# TECHNICAL BULLETIN

NO. 407-97-3

**MODELS AFFECTED:** 407

**SUBJECT:** IMPROVED CORNER MOUNT 407-310-203-101, INTRODUCTION OF.

**Figure 1. Installation of studs (Sheet 1 of 2)**

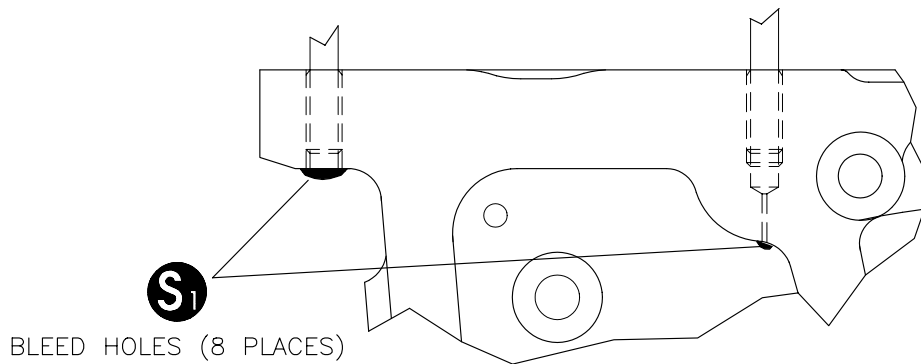
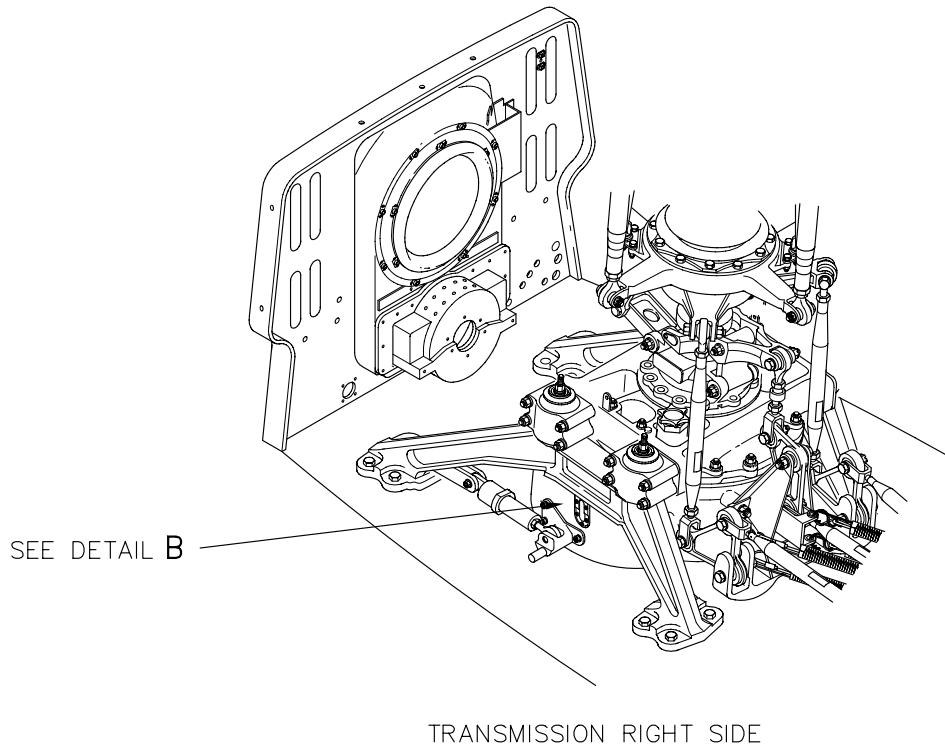
1. Use a heat lamp or equivalent to heat-soak the top case. Increase the temperature of the top case to 250-300°F (121-149°C). Let the heat go through the top case until the epoxy polyamide primer becomes soft and permits you to remove the studs. Use the stud extractor to remove the 16 corner mount studs 406-040-079-103 and -115 from the top case assembly and discard them (Refer to Standard Practices Manual, Chapter 8).
2. Remove the sealant blocking the bleed holes behind the studs on the transmission top case (Figure 1). Make sure that the bleed holes are not blocked.
3. Use a cotton swab moist with MEK (C-309) to clean the threads in the transmission top case bleed holes and on the new studs.
4. Let the transmission top case cool to room temperature. Install the studs 406-040-079-127 wet with unreduced epoxy

polyamide primer (C-204) (Refer to Standard Practices Manual and Figure 1). Seal the bleed holes with sealant (C-308).

5. Re-identify the transmission top case with the use of a vibrating stylus. The depth of the vibroetch must not exceed 0.005 inches (0.127 mm). Reidentify the transmission top case to 406-040-052-~~105~~-109FM (Figure 1). Apply aluminum touch-up solution (BHT-ALL-SPM, Chapter 3), to bare metal surfaces. Apply touch-up paint to all bare metal and new sealant.

**T** TORQUE STUDS TO 100-240 IN-LBS (11.3-27.1 Nm)  
TO GET AN INSTALLED  
HEIGHT OF 3.100-3.160 IN. (78.7-80.3 mm)

- ① The standard stud size is -127. However, larger or smaller size studs could have been installed during production. If you can not get the specified torque value and installation height, you will have to use the next larger size stud. Refer to Figure 2 for the identification of the studs.
- ② Vibroetch new dash number on transmission top case.

Figure 1. Installation of studs (Sheet 2)

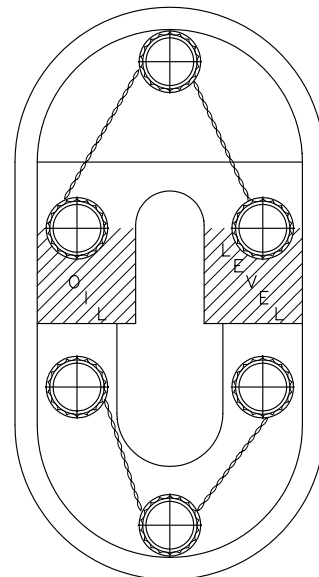
6. Re-identify the transmission assembly with the use of a vibrating stylus. The depth of the vibroetch must not exceed 0.005 inches (0.127 mm). Reidentify the transmission assembly to 407-040-006-~~103~~-107FM (Figure 1).

○ AIRCRAFT MOD. 407 ○
MFR CODE 407-040-006- <del>103</del> -107FM
PART NO.
CONT NO.
SERIAL NO. A-XXX
CONT. <input type="checkbox"/> CONT.
INSP. <input type="checkbox"/> CUST.
MODIFICATION INCORPORATED

Vibroetch new dash number on transmission identification plate.

Figure 2. Identification of studs

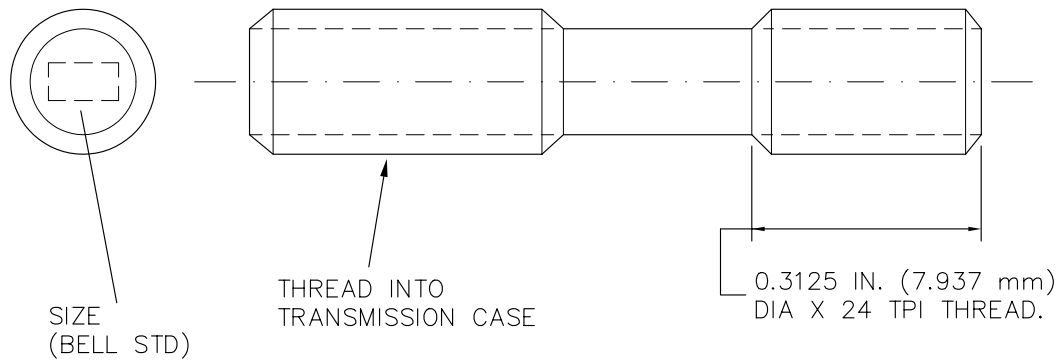
Note: The standard stud size is -127. However, larger or smaller size studs could have been installed during production. If you can not get the specified torque value and installation height, you will have to use the next larger size stud. Refer to Figure 2 for the identification of the studs.

UNDERSIZE AND OVERSIZE IDENTIFICATION	-.003	STANDARD	+.003	+.006
	-125	-127	-129	-131
